RELOCATION OF GATES 10 & 11

**PROJECT NO. 54 1019 1765
CONTRACT NO. 54-2-20-2111**

ADDENDUM NO. 1

March 27, 2020

BID DOCUMENTS
DRAWING: AE201
PROJECT: 54 1019 1765
SHEET: 91 OF 127

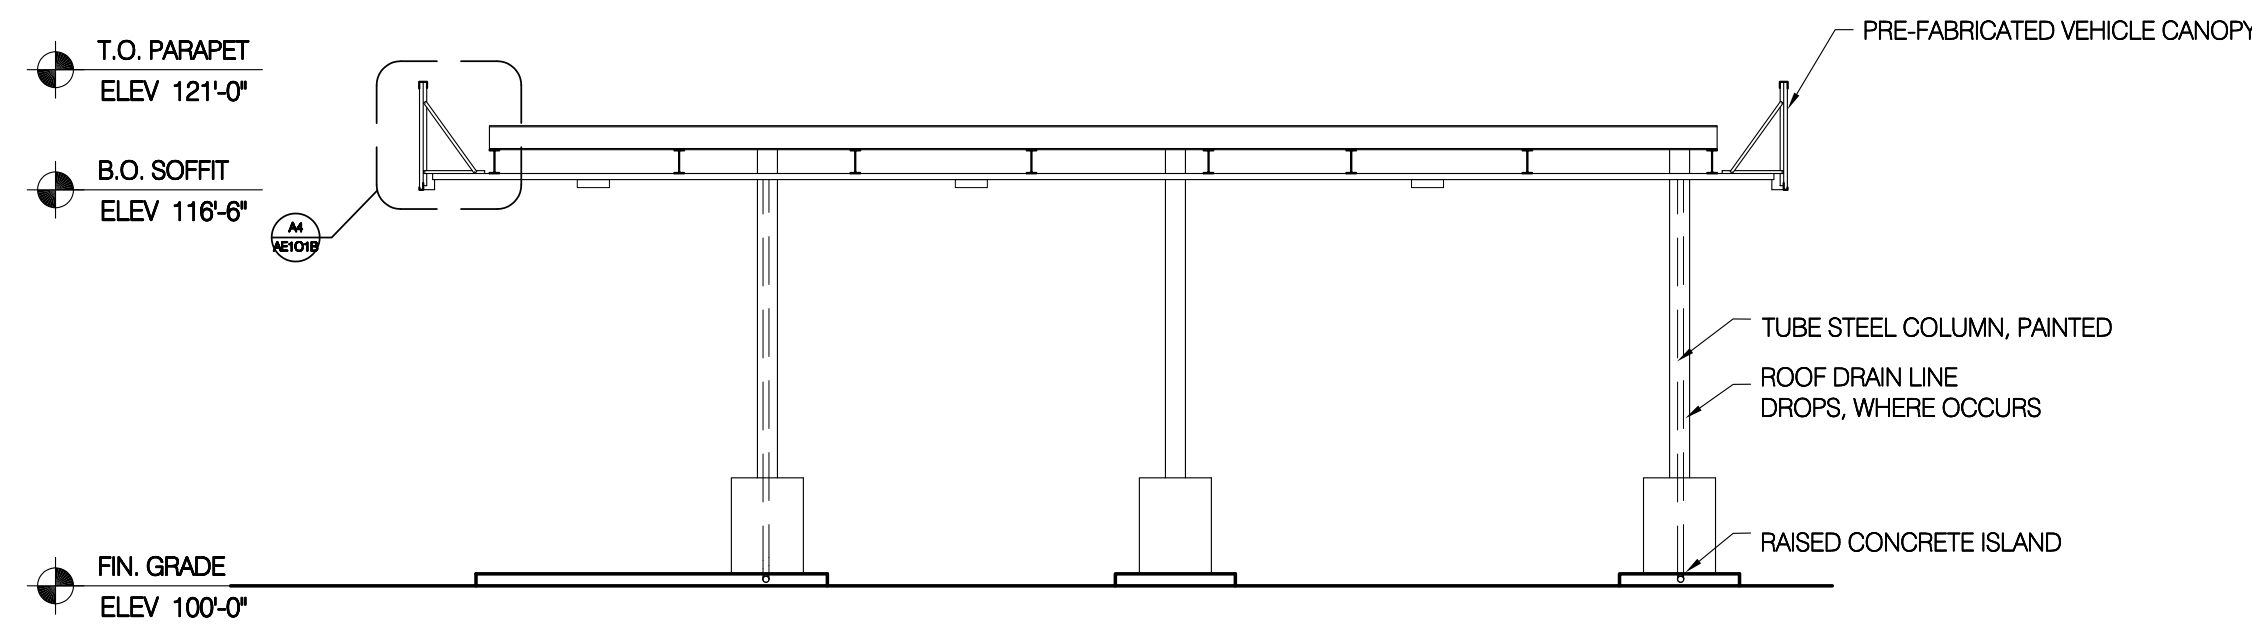
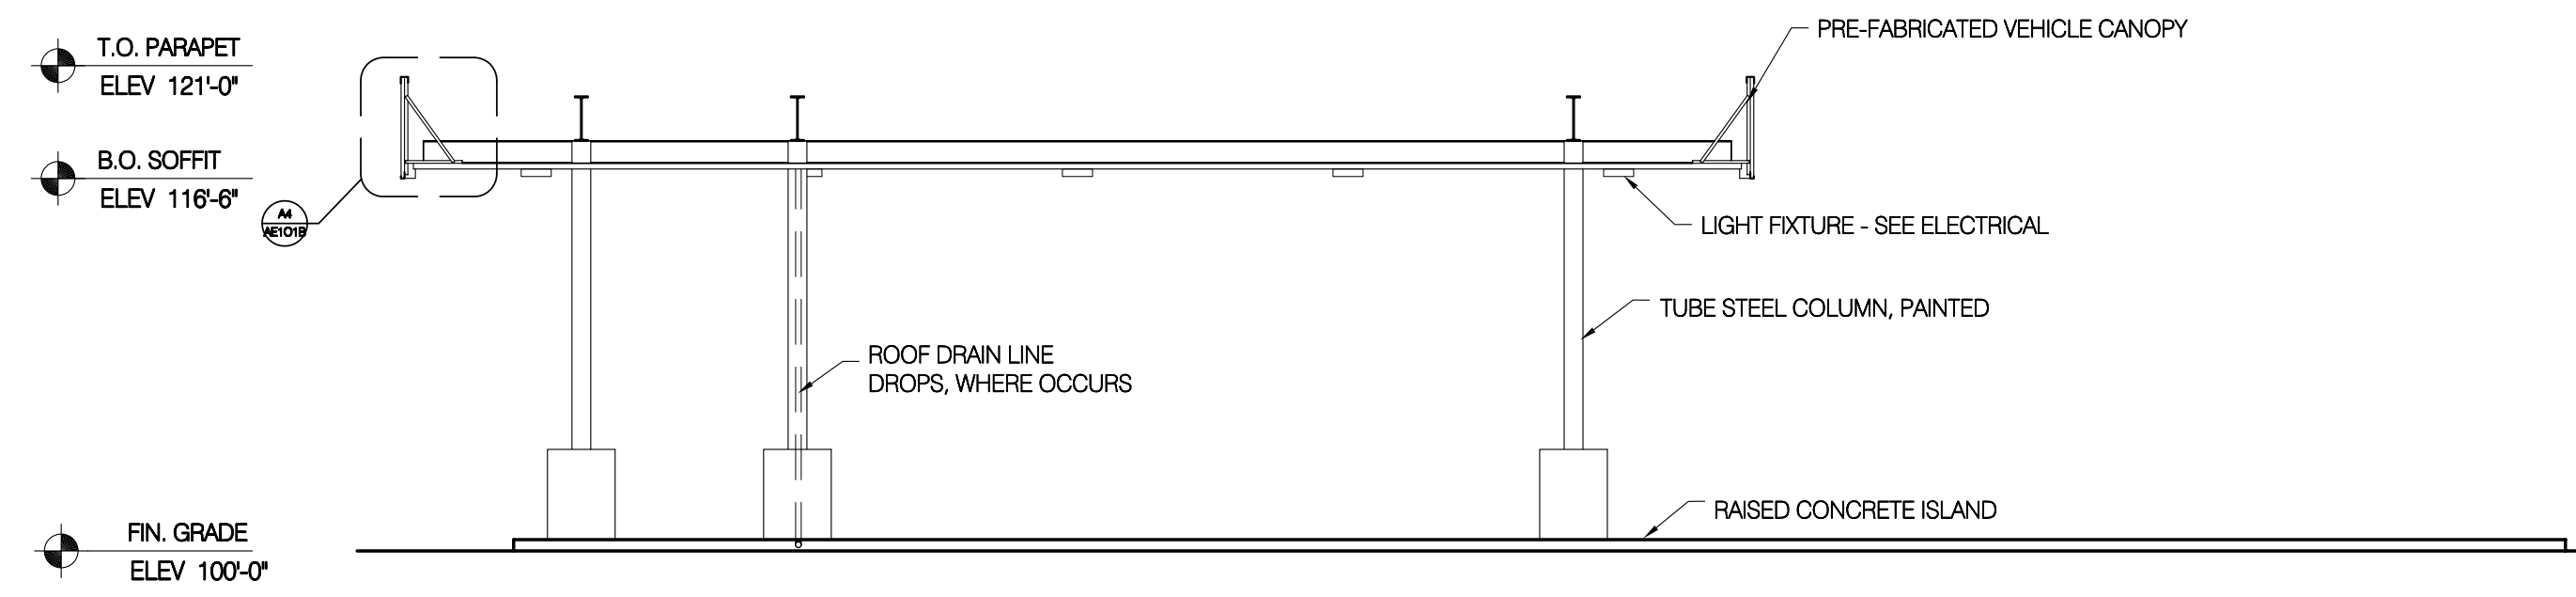
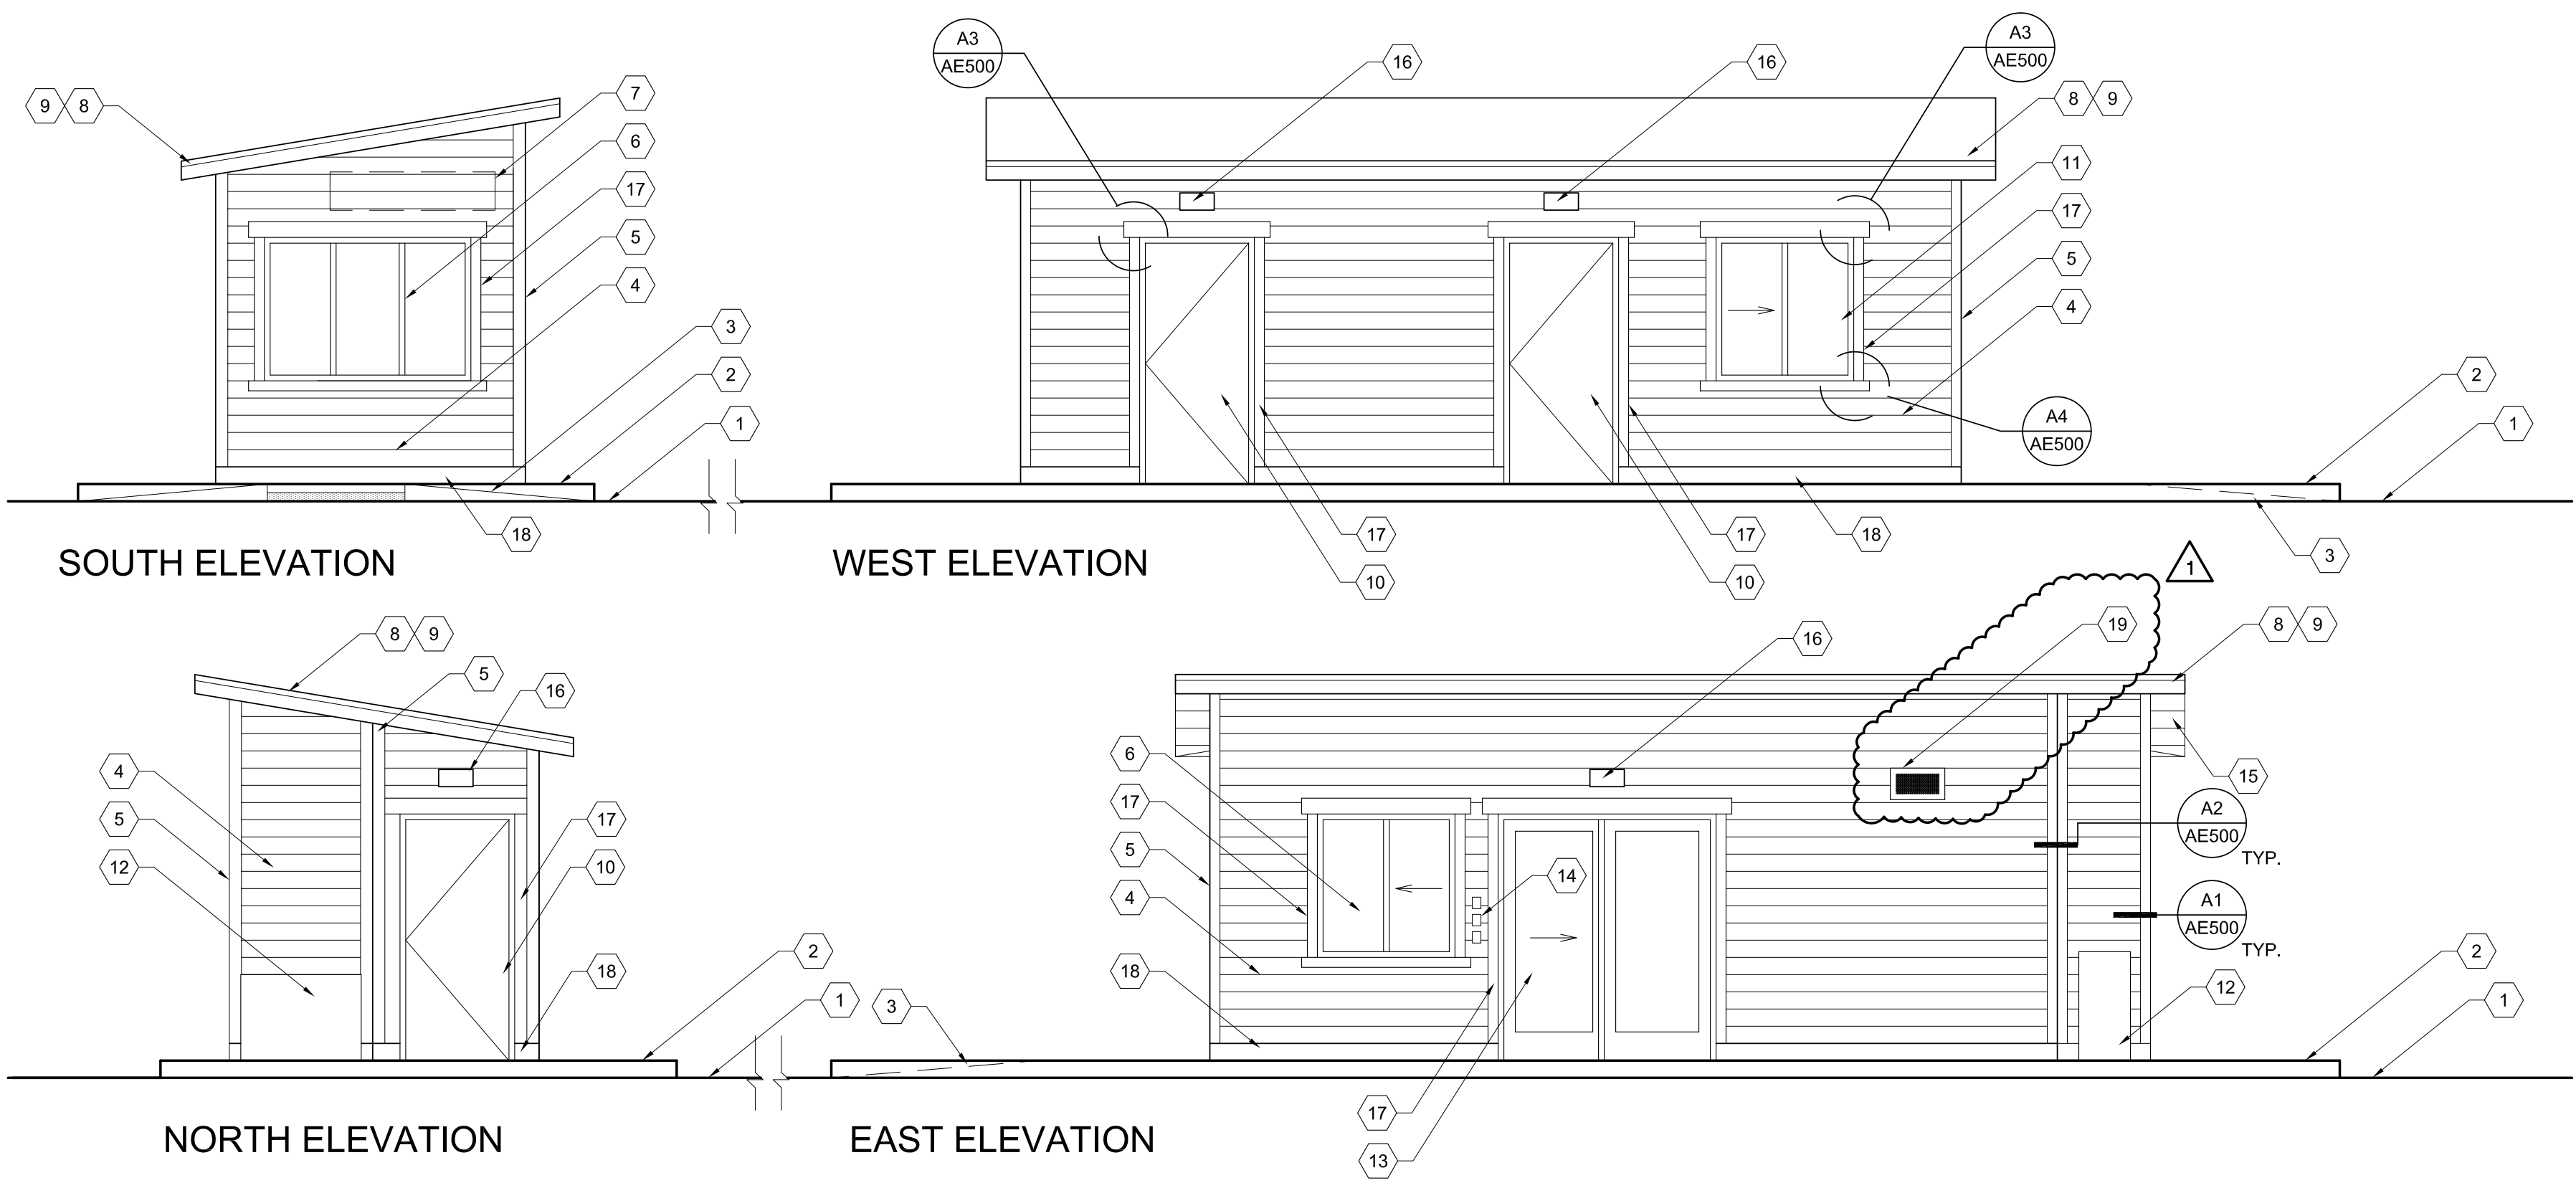
AE201 Addendum No. 1 - Updated east elevation to show exhaust fan grille.
